Subject: Comments of Casitas Municipal Water District on the State Water Resources Control Board (SWRCB) Development of Groundwater-Surface Water and Nitrogen Transport Models of the Ventura River Watershed (Ventura River Watershed Modeling Study)

Comments on California State Water Resources Control Board's Ventura River Watershed Integrated Hydrologic Model

01 April 2022

Figure 1. Spinner log from Casitas well SA-4

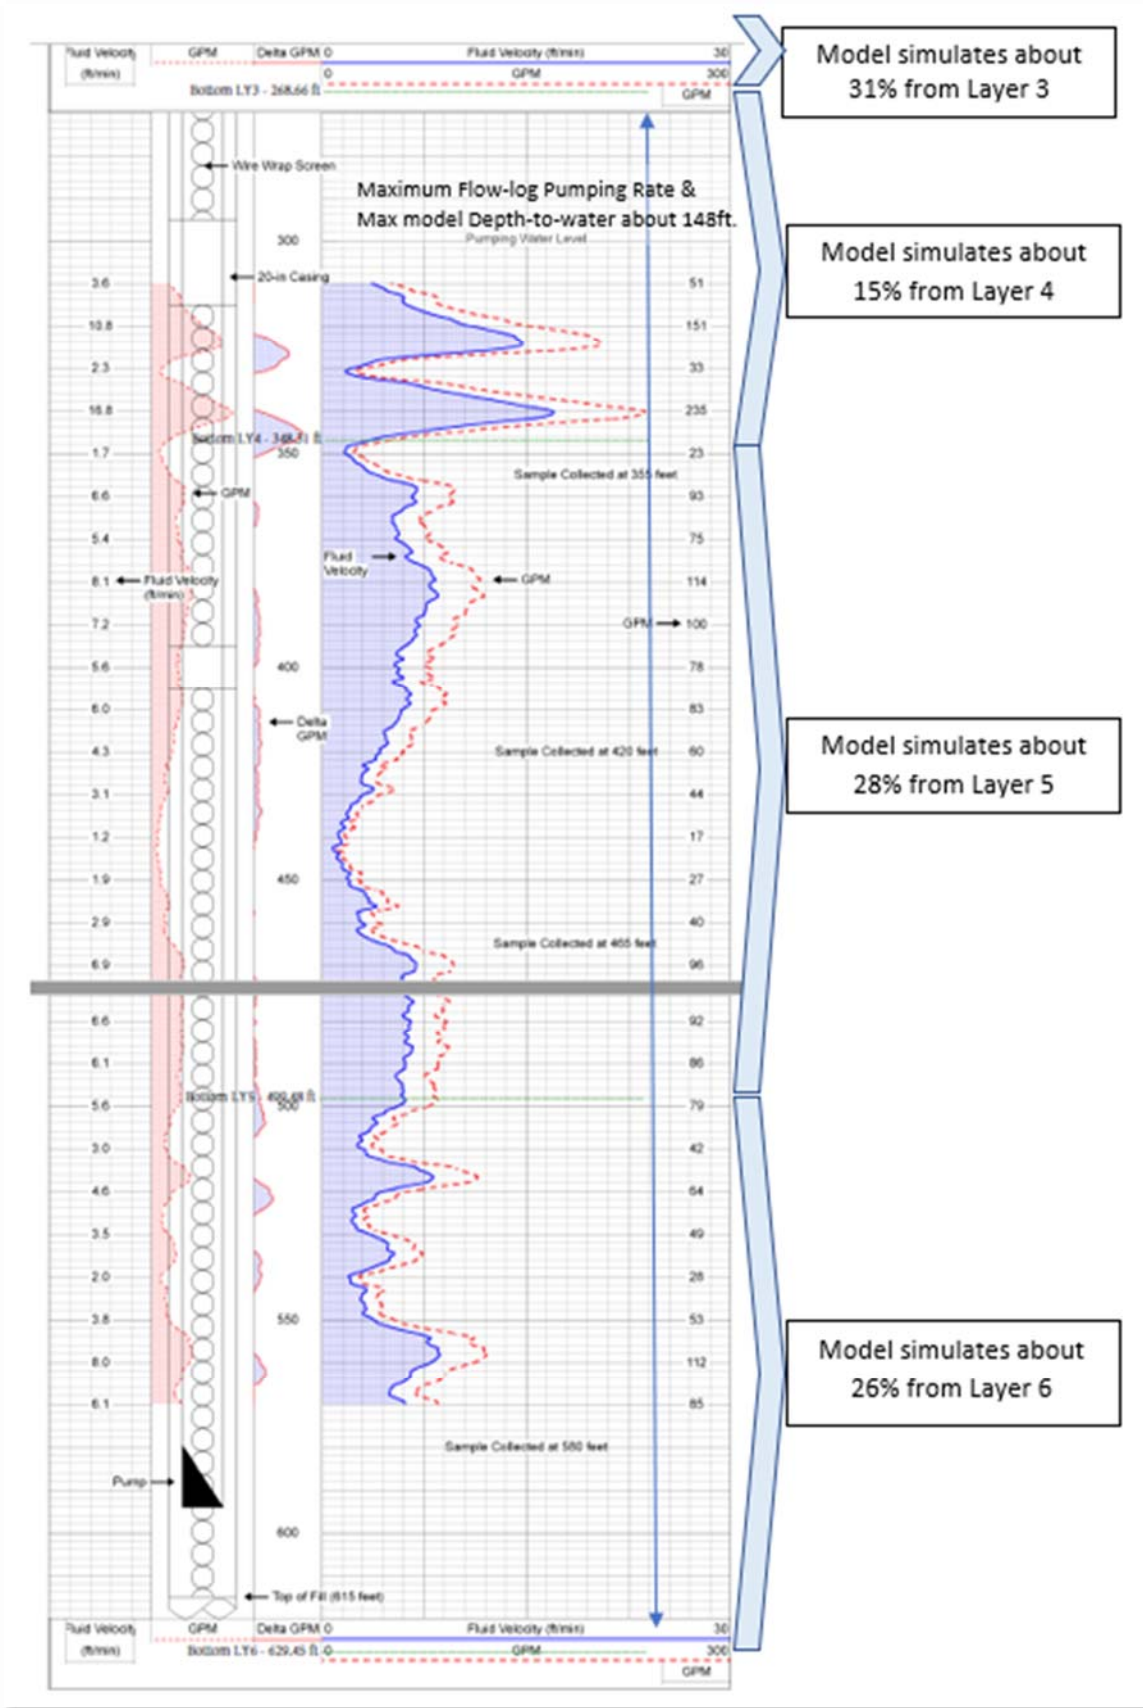
- (5) MNW2 representation of wells needs to be rebuilt to use SKIN factors (for each layer) combined with honoring the surface seal (this area is in Ventura County Surface seal zone 1, requiring a minimum seal extending 25 feet below the land surface up to 150 feet for some wells), partial penetration, and a better explanation of location and estimation of pump-depth locations. The features used in the MNW2 package are not consistent with the actual nature of well performance and well construction. The MNW2 should have differentiated between older wells completed with cable-tool methods versus more modern rotary-drilled wells, and small domestic versus larger supply wells, as was done for the RGTIHM model (Hanson et al., 2020).

Finally, the data and information previously presented in Section 2.3(5) also points to the groundwater system in the Ojai Basin to be highly stratified, with the extreme well scaling occurring due to mixing of groundwaters of different chemistries encountered at different depths.

Figure 2. Scatter plot of observed versus simulated heads for VRW calibration model 95-GHB

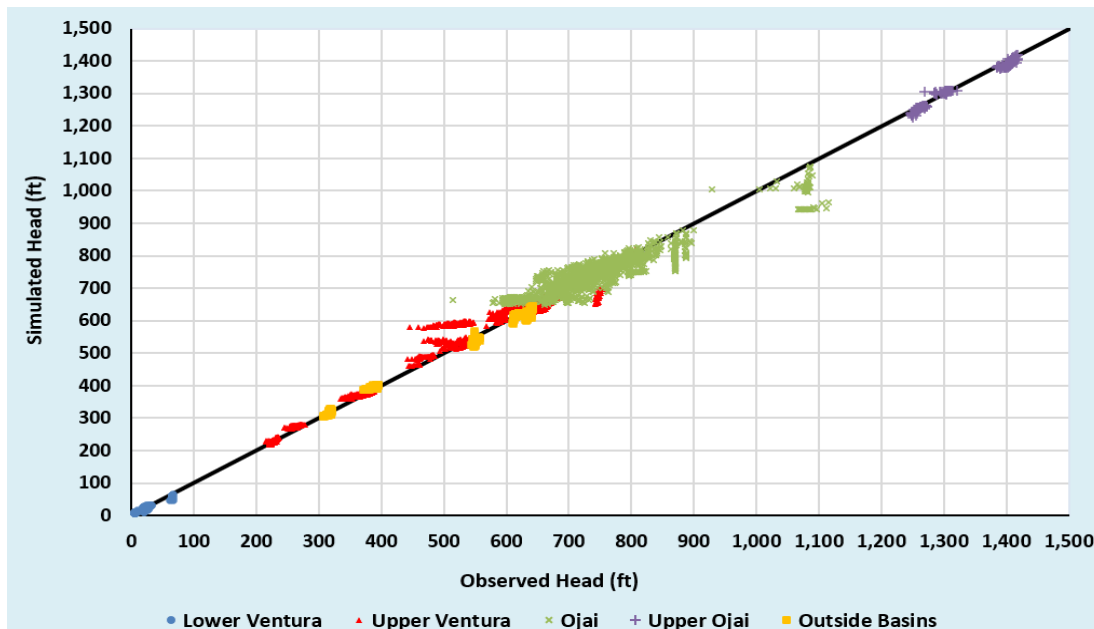
We agree with Preston and Schnaar’s statement that a well calibrated model will exhibit simulated and observed water levels falling near the 1:1 line, and that overall at the plot scale most of the points do fall along a tendency scattered about the 1:1 line. When reviewing the calibration scatter plot in detail, however, it becomes obvious that the simulated groundwater levels at some wells do not comport with the observed water level data. Specifically, in the scatter plot one can see several clusters of points that have a horizontal tendency (red triangles, representing Upper Ventura Basin wells) or a vertical tendency (green crosses, representing Ojai Basin wells); these represent individual wells which are being poorly simulated by the VRW model, indicating potential structural errors in the model. The use of model statistics overlooks the analysis of structural and systematic errors. For example, the use of error statistics of residuals of Measured minus Observed heads help identify the substantial issues of systematic errors in the Ojai Basin not highlighted by the overall model goodness-of-fit statistics, as shown below in Section 3.2.1 (**Fig. 4**).

Referring again to the head-calibration scatter plot in **Figure 2**, those clusters of green crosses with a vertical tendency represent Ojai Basin wells that suggest structural error in the model. Specifically, for these wells, the data shows very little head variability and relatively low fluctuations consistent with unconfined conditions. The simulated heads, on the other hand, exhibit much larger variations, more akin to semi-confined and confined conditions. This divergence between model and observation is further underlined when plotting the head error versus observed head, as shown in **Figure 7**. Again, a handful of well clusters in the simulated vs observed scatter plot exhibit a vertical tendency. Investigating which wells have this behavior, it was determined that in all cases it was data from shallow wells. This seems to suggest that the VRW model is doing a poor job at simulating shallow wells in the Ojai Basin, specifically wells completed in the shallow perched system.

Figure 3. Scatter plot of simulated versus observed groundwater levels in Upper Ventura River Basin

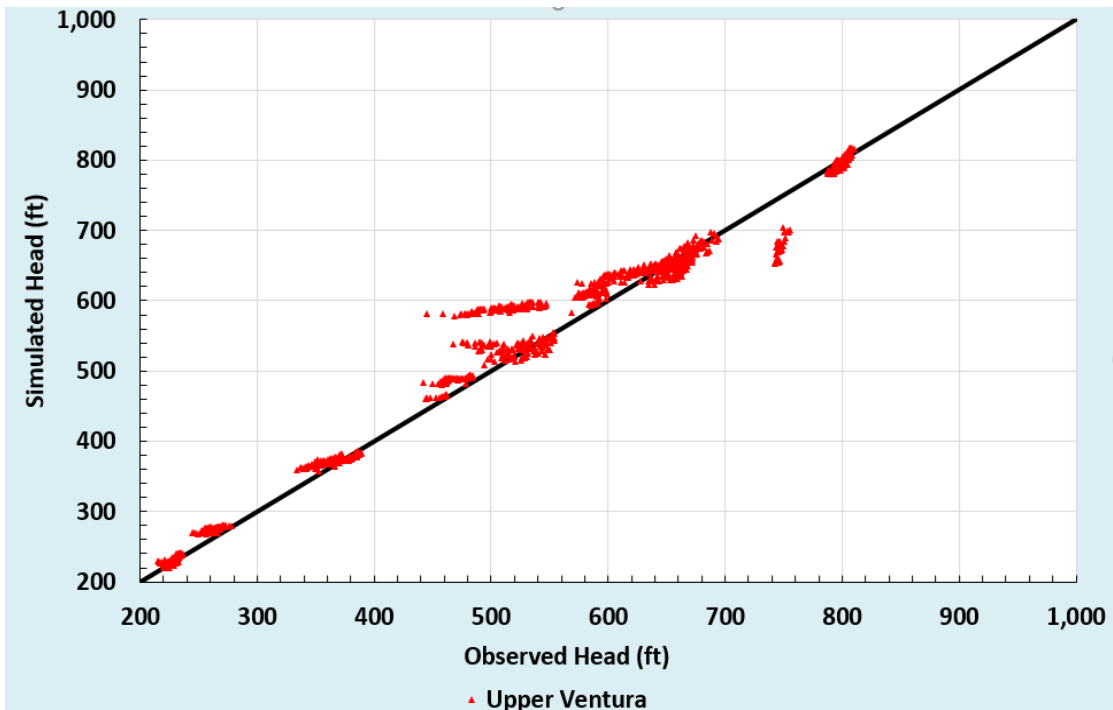
Figure 3 shows the calibrated model observed vs simulated head scatter plot for only the wells located in the Upper Ventura River Basin. **Figure 4** shows a scatter plot of model error (measured minus simulated water level) versus measured water level. A few key observations can be taken from these plots:

1. For observed groundwater levels between 300 feet amsl and 650 feet amsl, the model generally overpredicts groundwater levels (illustrated by preponderance of negative residual values in **Fig. 4**), this is particularly true for observed groundwater levels between 400 and 650 feet amsl.

2. In this range of observed groundwater levels, the VRW model commonly overpredict groundwater levels by 10 feet or more, and for well 04N23W15D02S the model typically overpredicts groundwater levels by more than 50 feet.

3. Furthermore, for these same wells the VRW model also predicts the simulated groundwater levels (vertical axis) to vary over a very narrow range while the measured groundwater levels (horizontal axis) are observed to vary over a large range, leading to the relatively “flat” tendency of those wells in **Fig. 3**.

Figure 5. Ventura River flows at Meiners Oaks as observed and simulated by the VRW SW-GW model (reproduced from Figure 2.3.1-12 from Preston and Schnaar, 2021a)

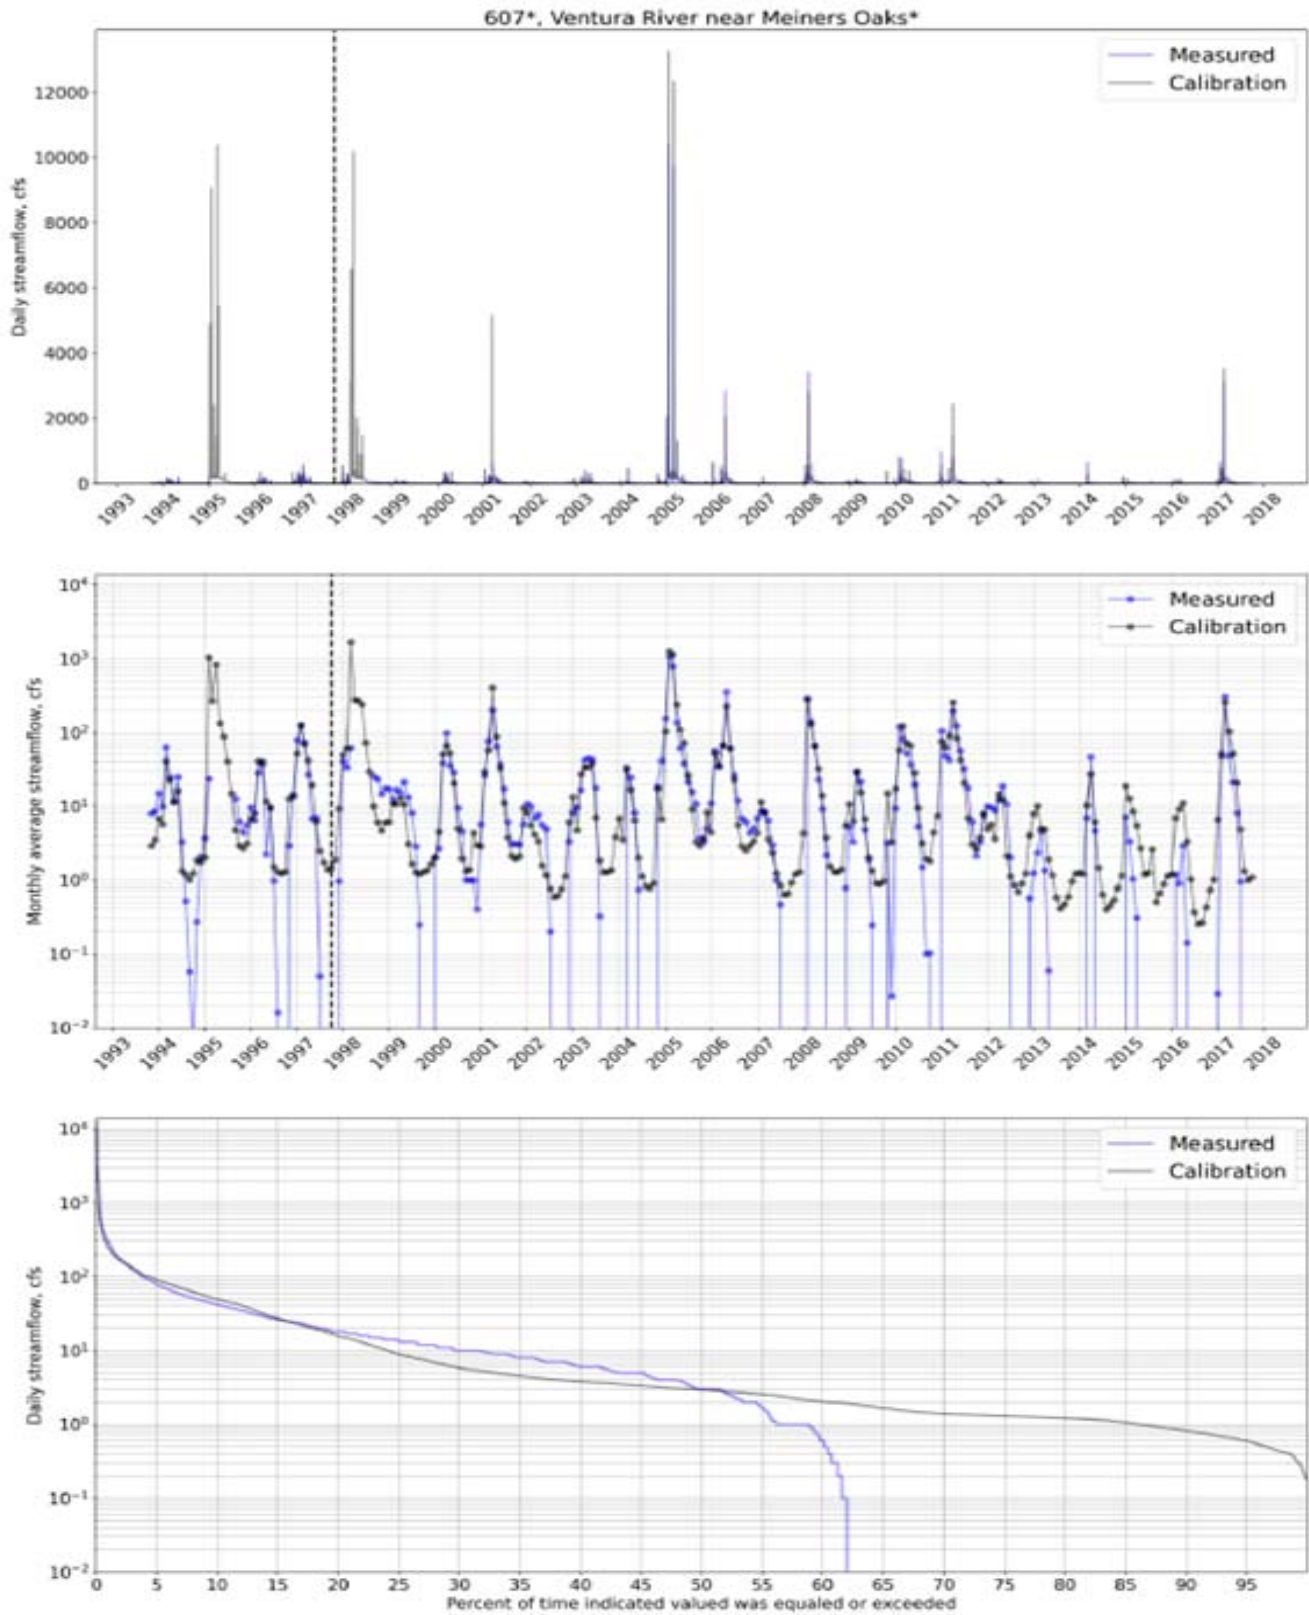
5. **Figure 5** shows the simulated streamflows versus observed streamflows at the Ventura River at Meiners Oaks gage, located on the intermittent reach. Focusing on the middle and bottom charts, one can see that the model significantly overestimates flows in the low flow range at this location. This is consistent with the overpredicted groundwater levels cited above

Figure 6. Stream channel width versus flow for the Ventura River near Foster Park gage, per direct measurements and as simulated by the VRW SW-GW model

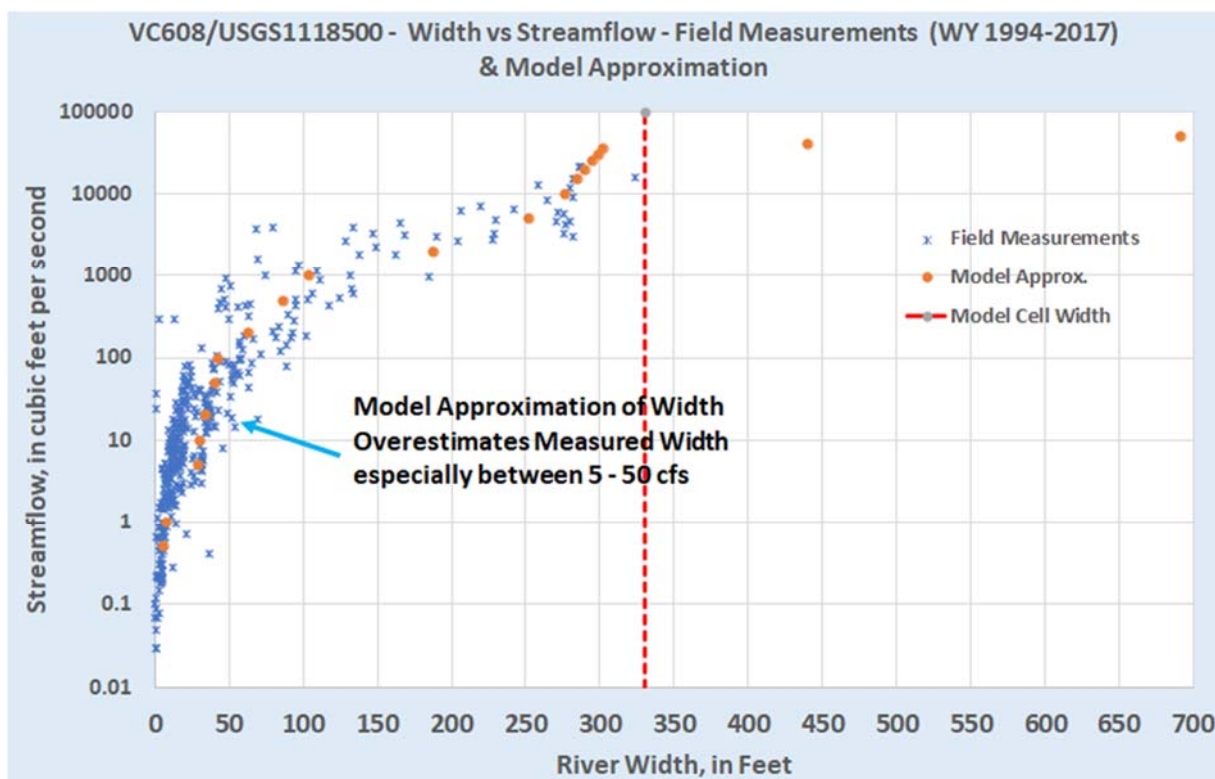
6. In addition to the overestimated groundwater levels, review of the model SFR channel width specified in the model compared to rating curve data for particular stream gage locations shows that in the flow range between 1 cfs and 50 cfs, the model greatly overpredicts the stream channel width (**Figure 6**). The combination of these two model biases likely means the model is greatly overpredicting groundwater discharge to the stream channel over the simulation period.

Figure 8. Well completion diagram of South Fulton Street nested-well site, with observed groundwater levels compared to VRW model simulated levels

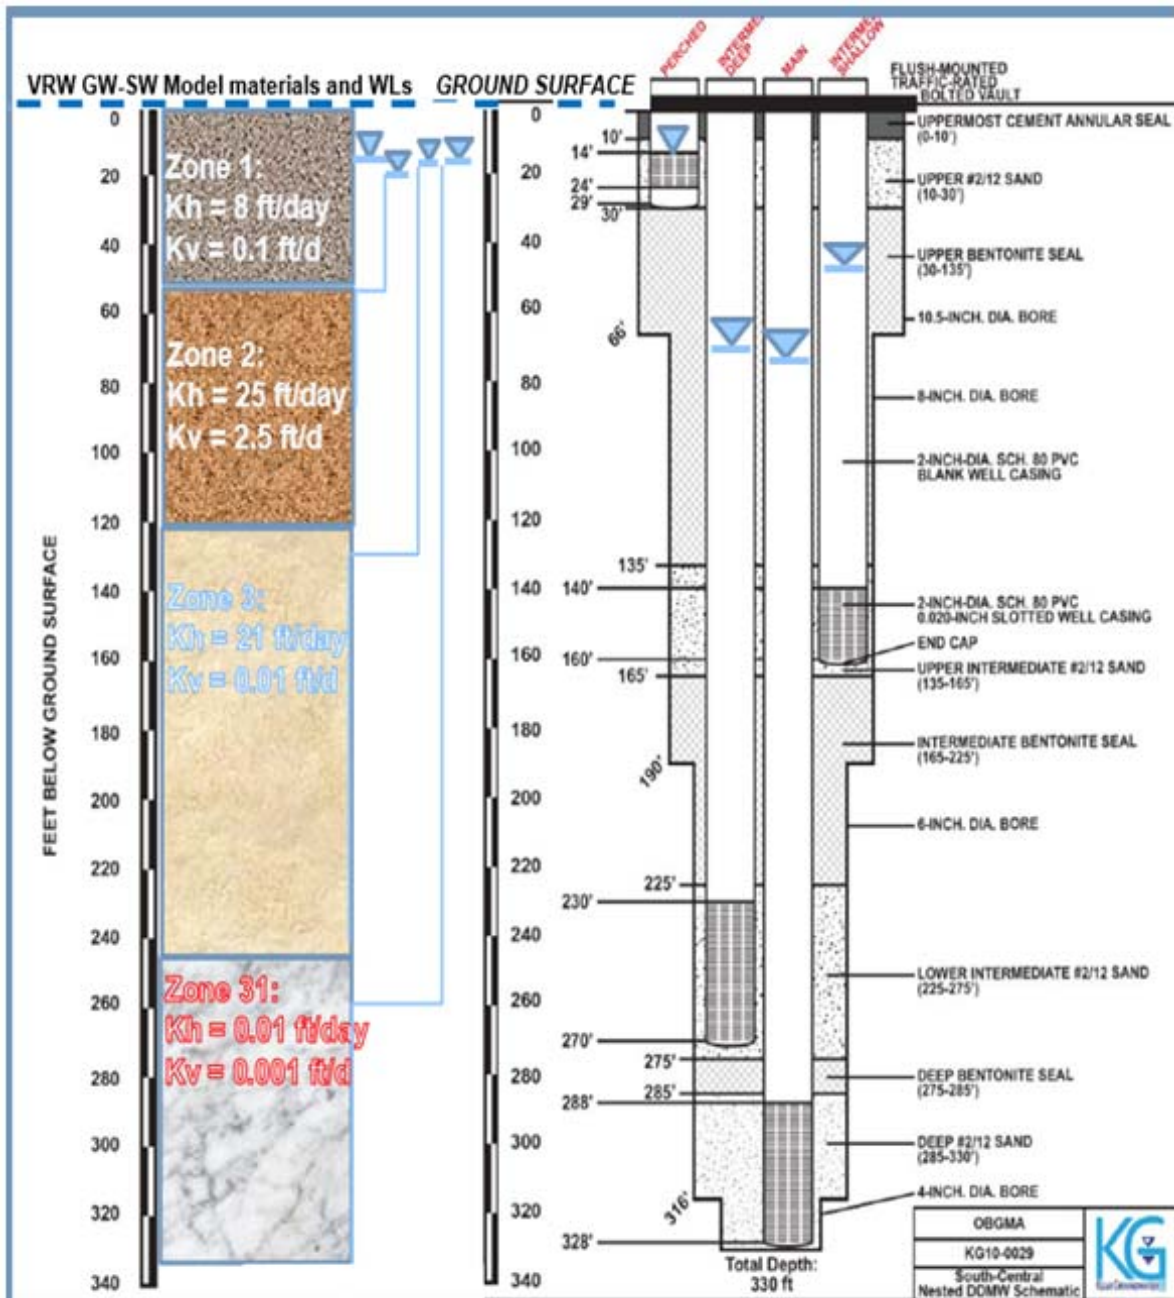
The presence of this clay layer and its impact on groundwater conditions in the basin is clearly illustrated by the South Fulton Street multi-level well nest installed in 2019 (Kear, 2021). **Figure 8** shows the well completion diagram of South Fulton Street (SFS) well nest. The driller's log indicated the clay layer is located between the 30- and 100-foot depth at that location, with perched groundwater above, dry horizons though that interval, and confined groundwater conditions below.

- (2) **Figure 8** also shows observed groundwater levels (right side) compared to VRW model simulated levels (left side). The water levels presented are from September 2017 which was a period of relatively low observed water levels due to the multi-year drought period that started in 2012, yet the modeled water levels remained relatively high.
